Technical Report #55

Cylinder head bolts: design changes on head & washer

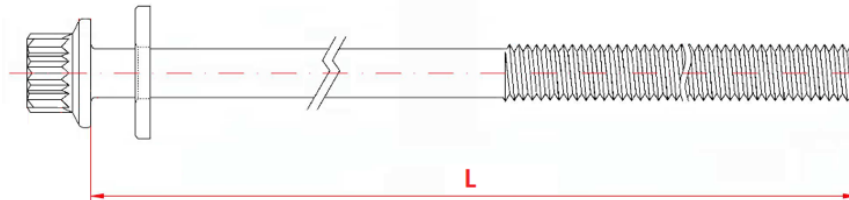
In some part numbers, the original manufacturer **changes the original design of the bolt**, which turns **from having a loose washer to include it in the head as a flange**. When the flange is included, the length of the bolt stem decreases (measured from under the head to the threaded end), because the thickness of the washer is included.

In these cases, Ajusa also adapts its bolts to the new design, being the part numbers involved the following:
